SAN ONOFRE NUCLEAR GENERATING STATION, UNIT 1

AMENDMENT TO PROVISIONAL OPERATING LICENSE

Amendment No. 42
License No. DPR-13

ATTACHMENT TO LICENSE AMENDMENT NO. 42

FIGURE 6.2.2.2
FACILITY ORGANIZATION

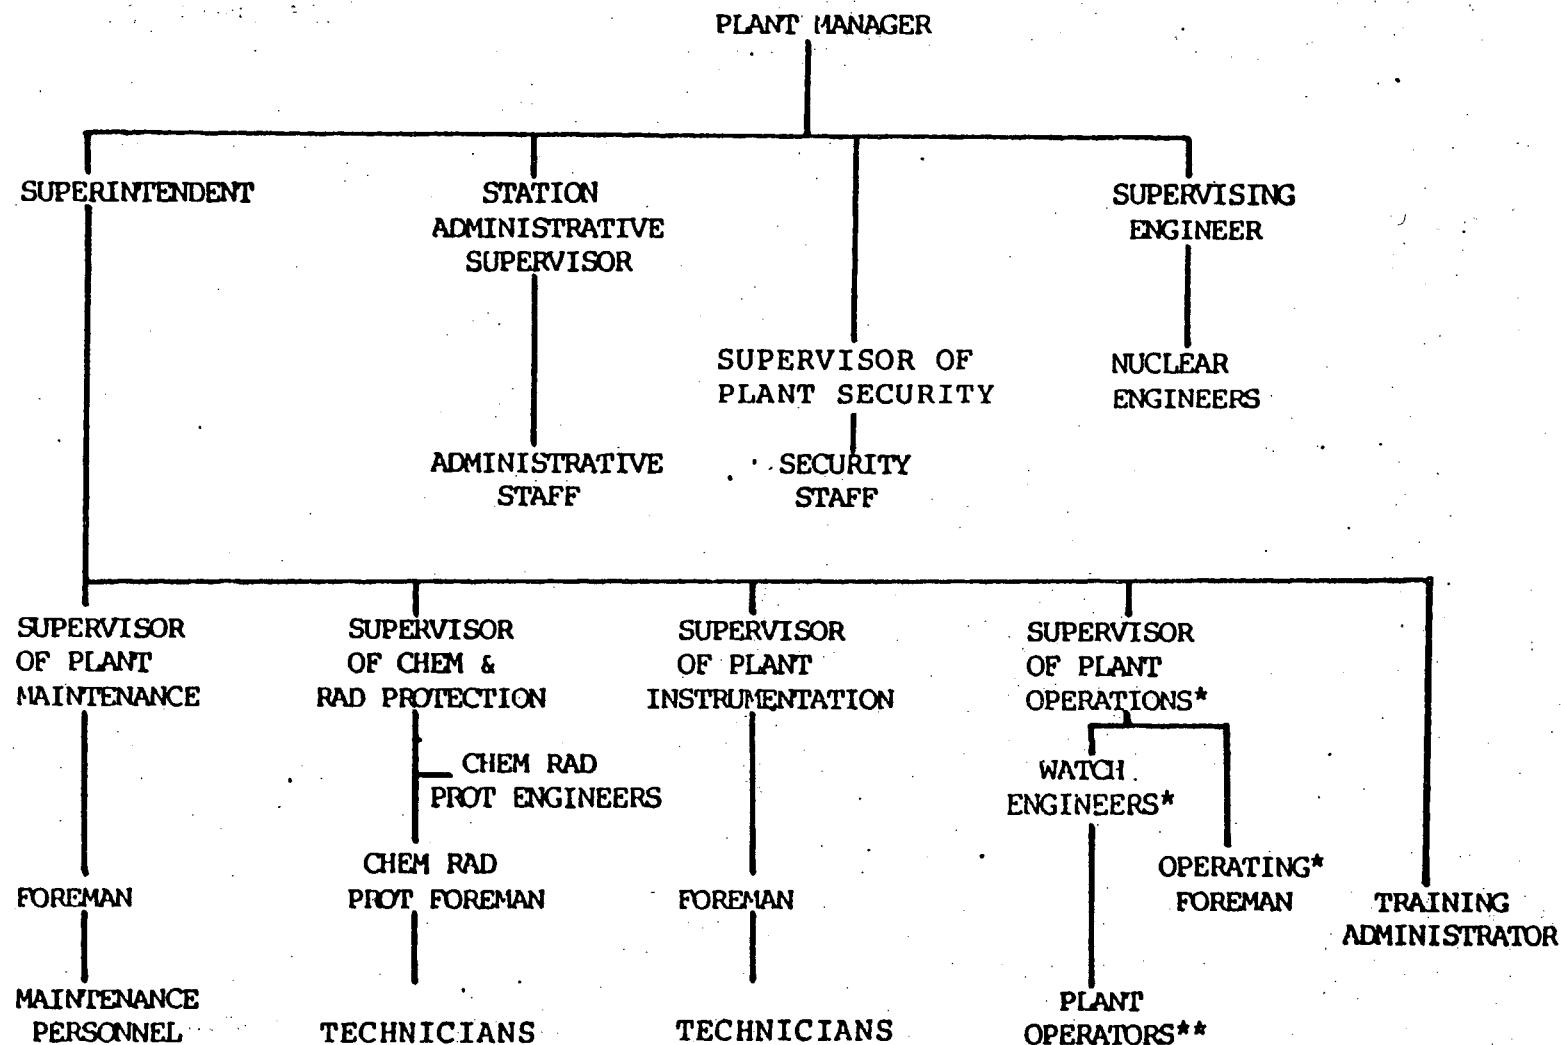
Revise Appendix A Technical Specifications and Bases and Appendix B Technical Specifications by removing the following pages and inserting the enclosed pages. The revised pages are identified by the captioned amendment number and contain vertical lines indicating the areas of change.
